DEVIATION REQUEST AND DECISION FORM

Project Name : Mayberry Phase 1
 Schedule No.(s) : PUDSP219, including SF1825 (Filing 1), VR2113 (Filing 1A), VR2322 (Filing 1B), SF2219 (Filing 3)
 Legal Description : NE1/4 of Sect 15 & N1/2 of Sect 14, Township 14 S, Range 63 W of 6th P.M., El Paso County, Colorado

A deviation from the standards of or in Section **2.4.1.E-1** of the Engineering Criteria Manual (ECM) is requested.

2.4.1.E-1: Roadway Access Design Criteria – Residential Access Width (i.e. width of driveway)

EXHIBIT 'C'
Example Deviation Compliant
Driveway Block Layout
(Actual As-Sold Configuration)

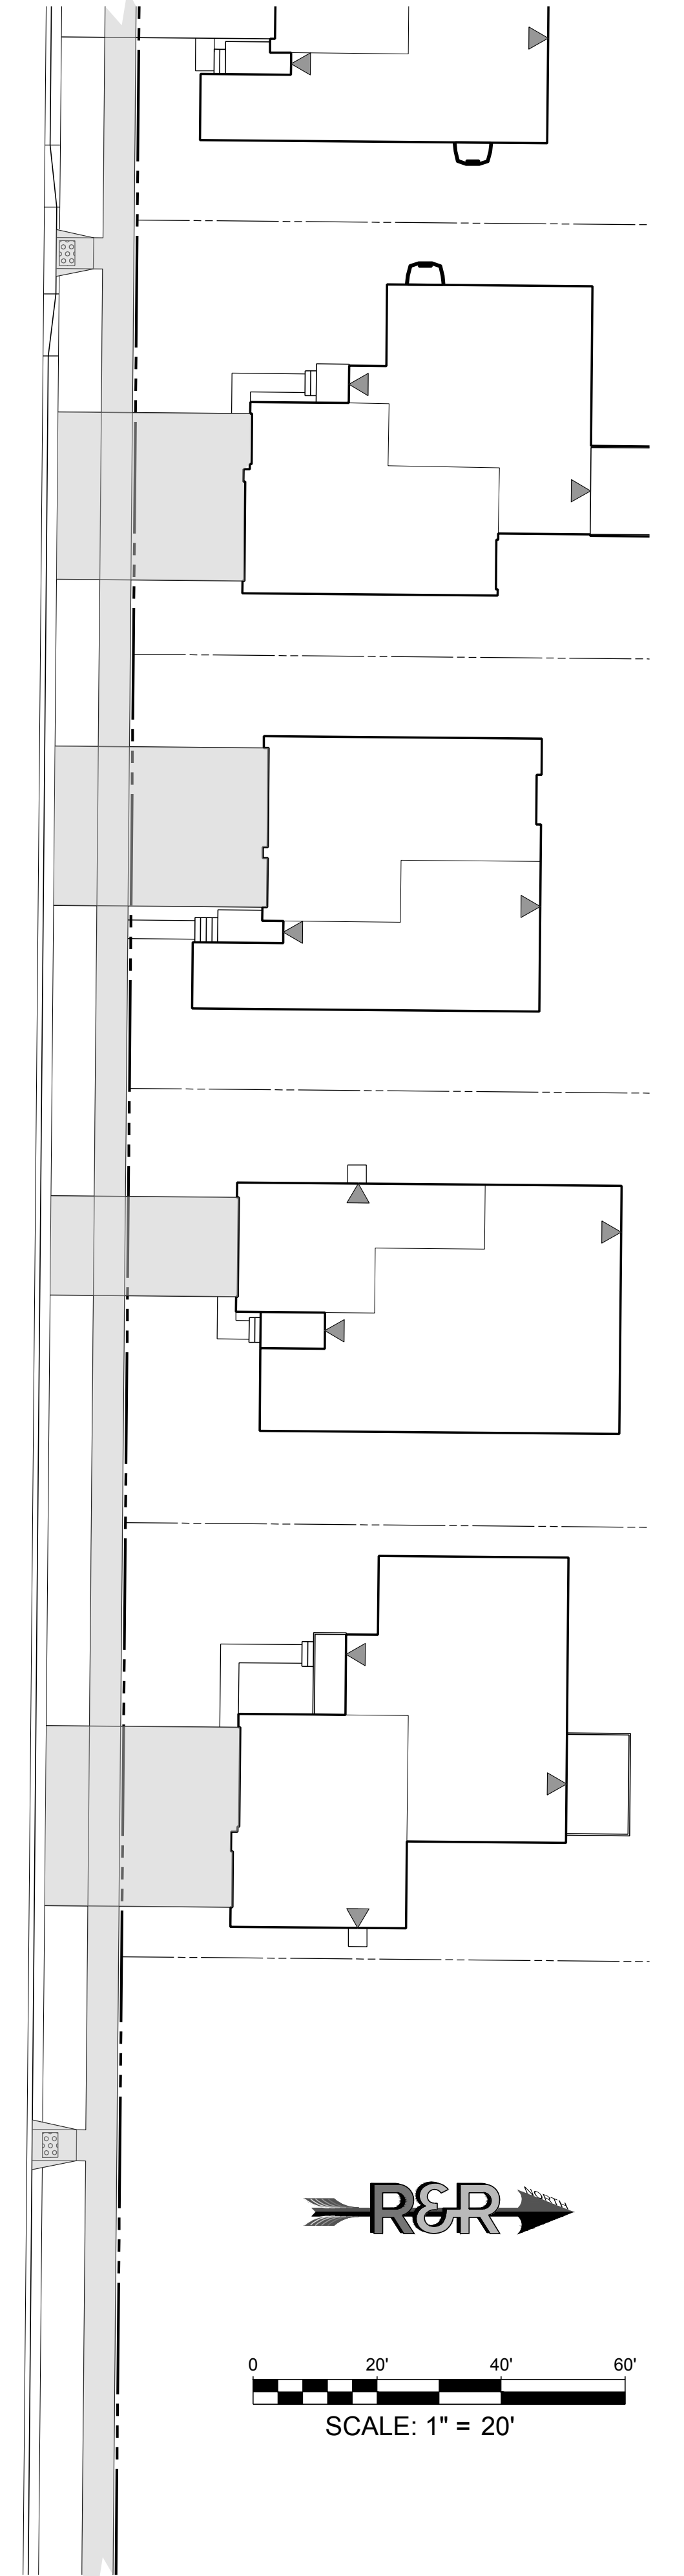
The Exhibit 'B' provides a schematic illustration of lots 45' in width with ECM maximum 24' wide driveways, all evenly spaced, while Exhibit 'C' illustrates a sample block layout of actual Mayberry homes designed with driveway layouts conforming to the criteria requested through this deviation request. These exhibits demonstrate that this deviation meets the design intent and purpose of the ECM standards.
